ADDENDUM No. Two (2)

IFB No. 2022-198

CONSTRUCTION, EXTERIOR REPAIRS TO SECOND FLOOR WALKWAY & FIRST FLOOR SOFFIT,
900 E. PARK BLVD., PLANO

ADDENDUM NO. 2

Sheet No. **S2.0**

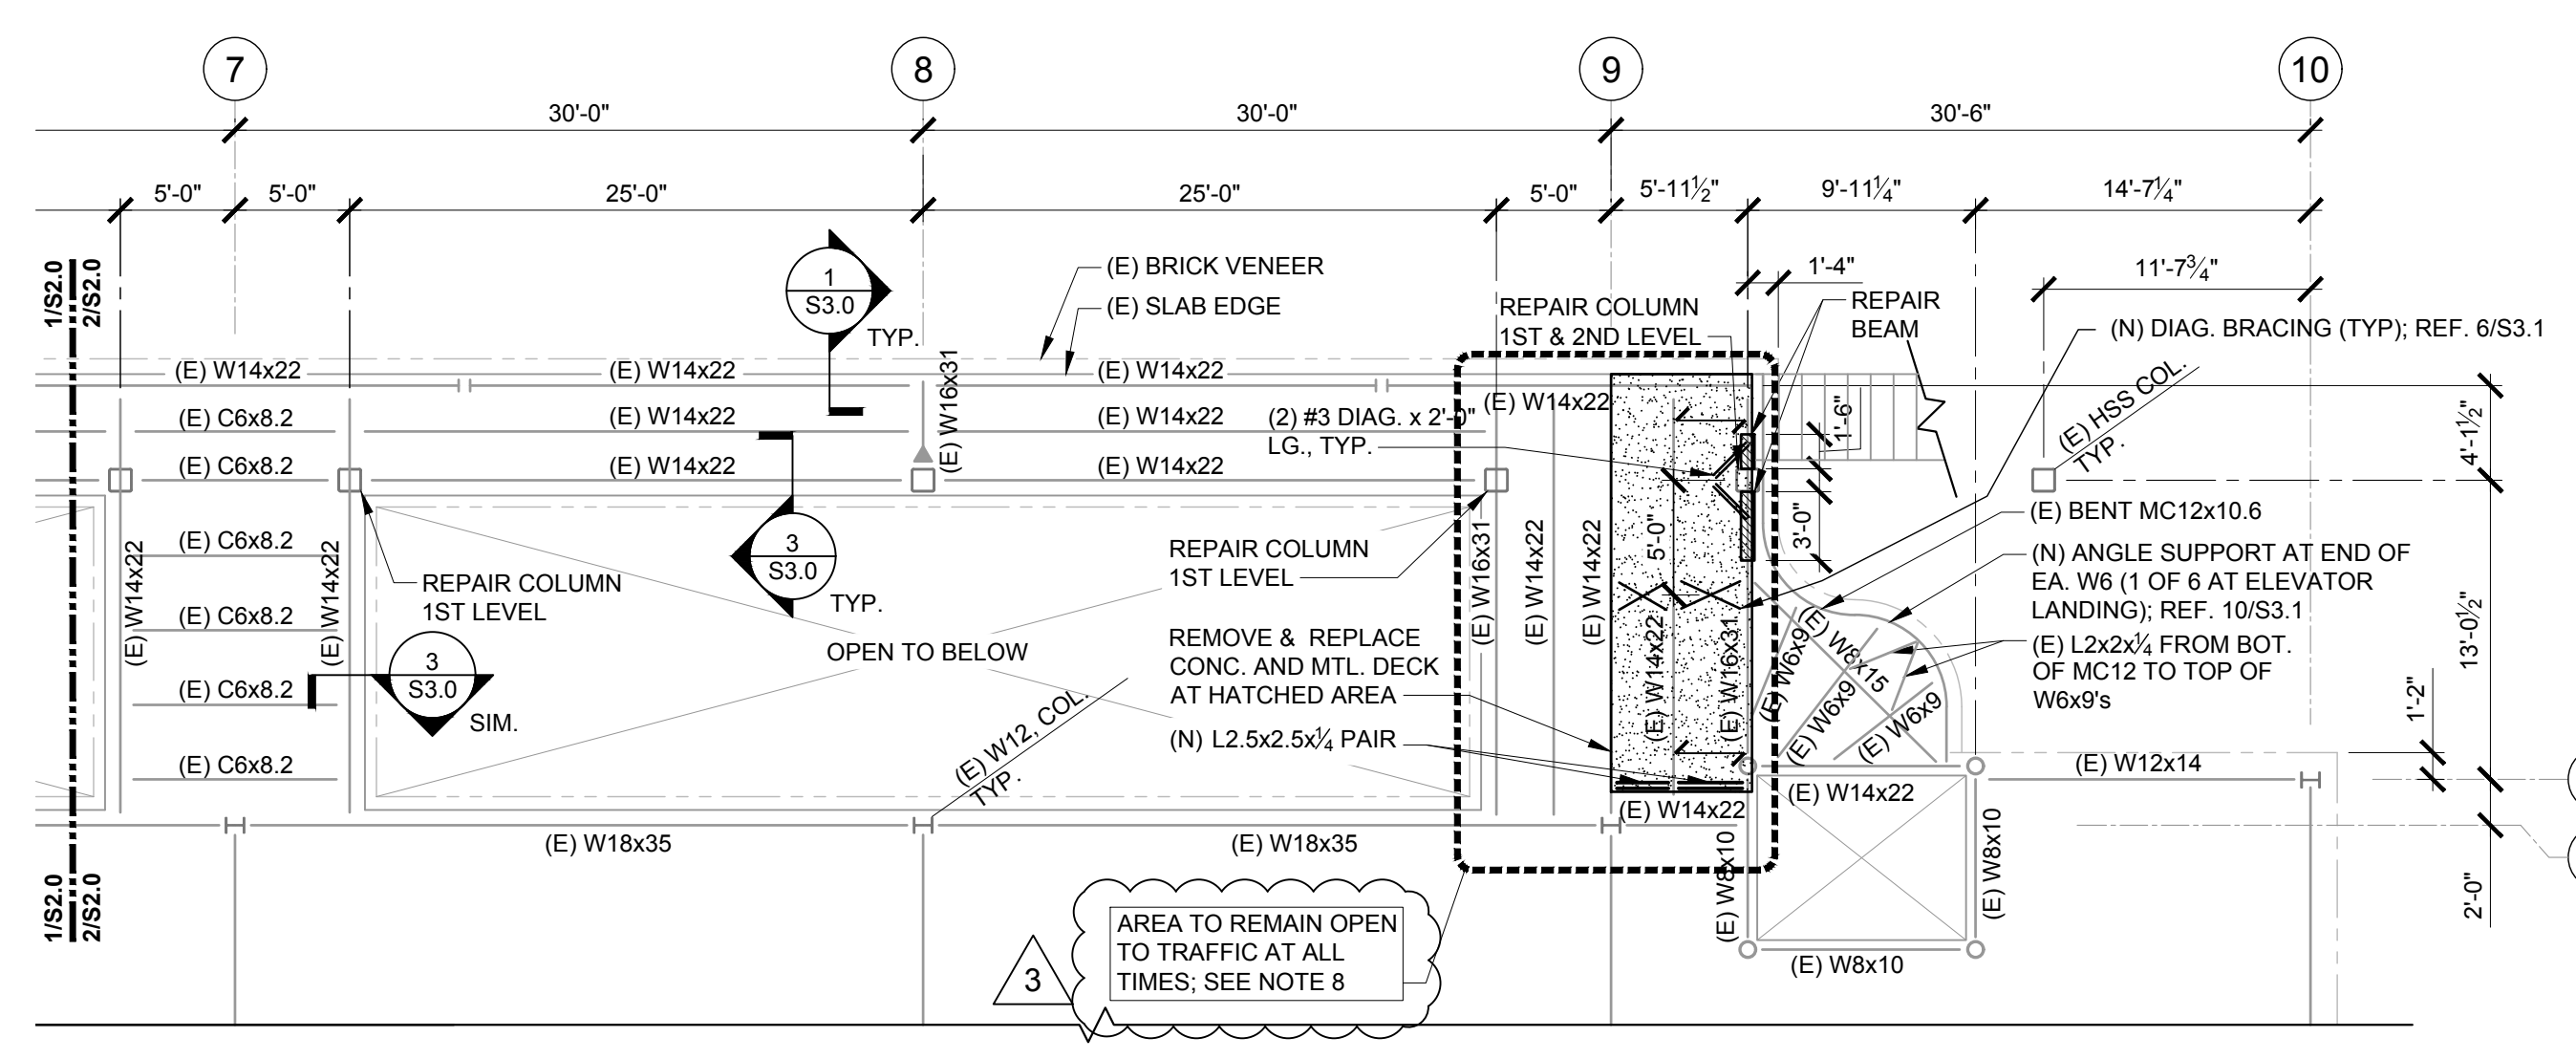
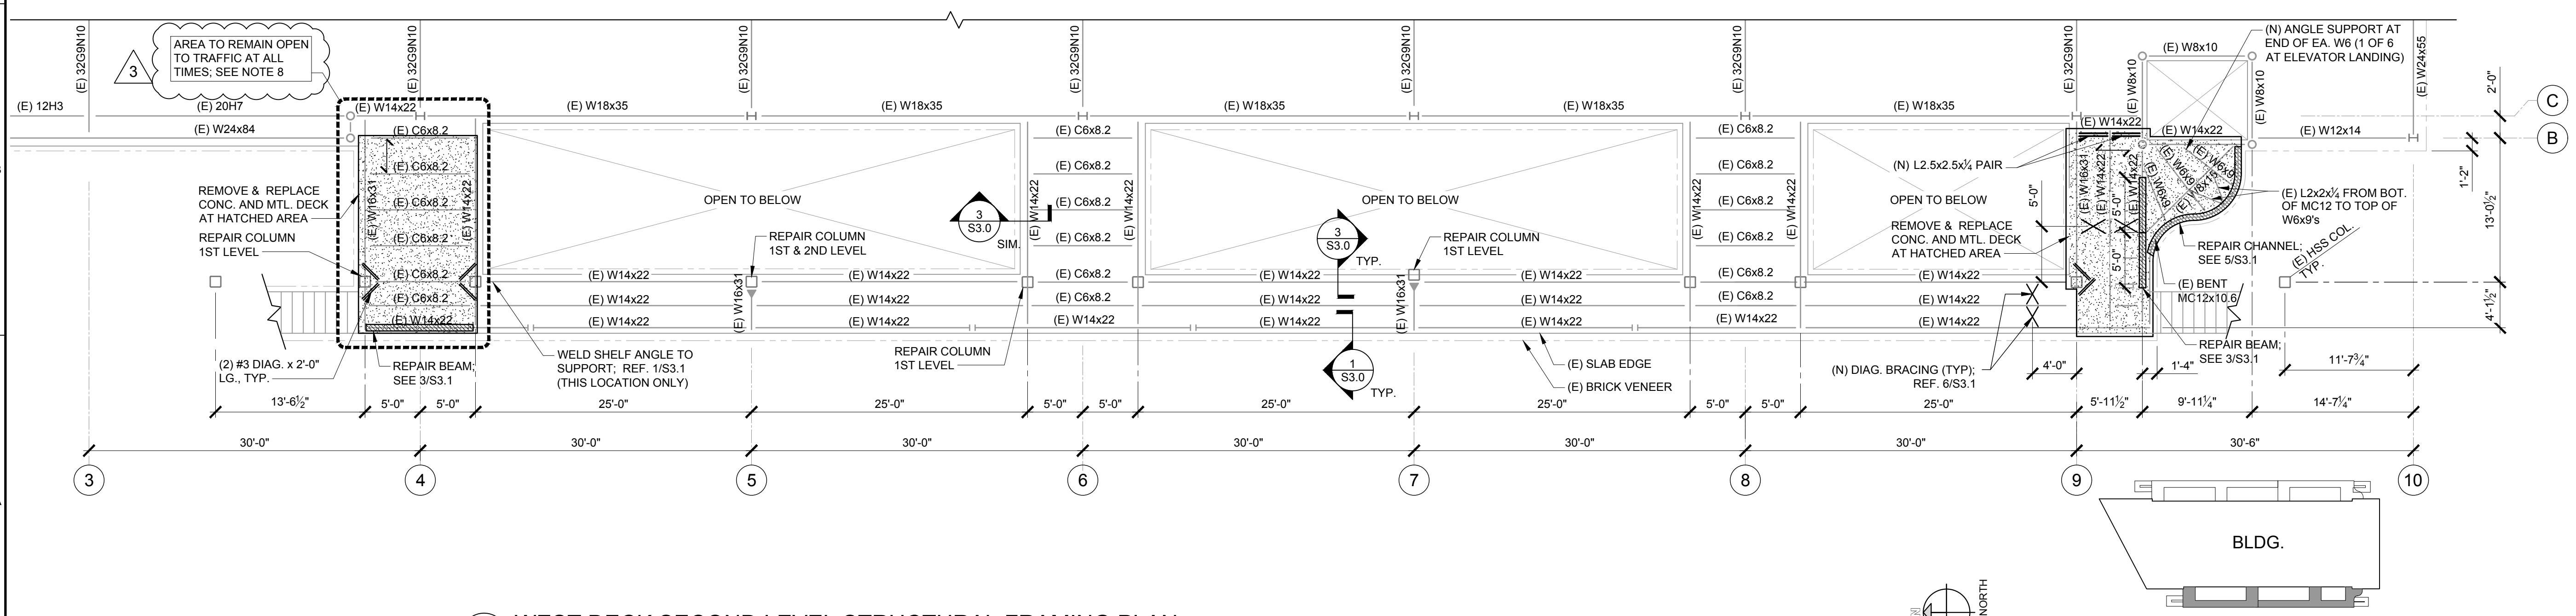
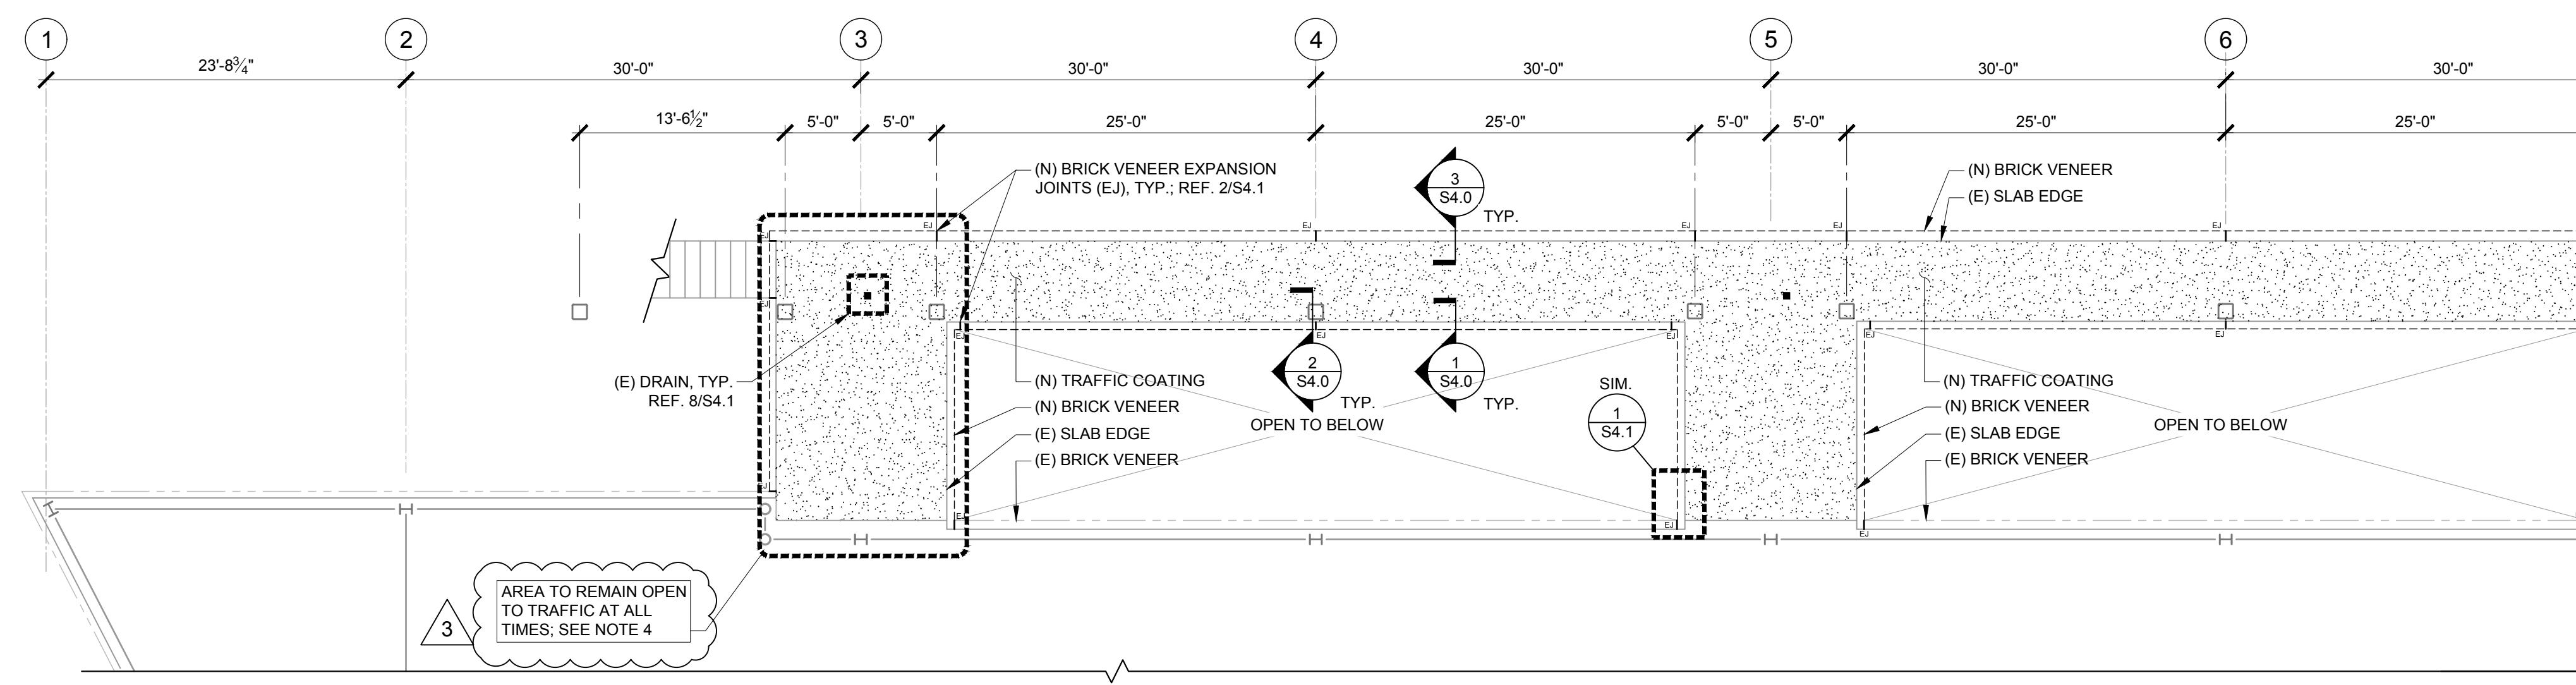
<i>Item</i>	<i>Sheet</i>	<i>Description</i>
1.	S2.0	Added requirement to provide temporary walkway at northeast, southeast, and northwest entrances at Level 2 to allow defined areas of Level 2 to remain open to traffic during normal business hours.
2.	S2.1	Added requirement to sequence traffic coating application at northeast, southeast, and northwest entrances to allow defined areas of Level 2 to remain open to traffic during normal business hours.

- REFER TO ARCH. FOR FLOOR DRAIN REPLACEMENT LOCATIONS. SUPPORT FOR NEW DRAINS SHALL BE PER 14/S3.1.
 - PROVIDE A TEMPORARY WALKWAY SURFACE AT LEVEL 2 AND SEQUENCE WORK AS REQUIRED TO ALLOW FOR AREAS INDICATED ON DRAWINGS TO REMAIN OPEN TO PEDESTRIAN TRAFFIC DURING NORMAL BUSINESS HOURS.
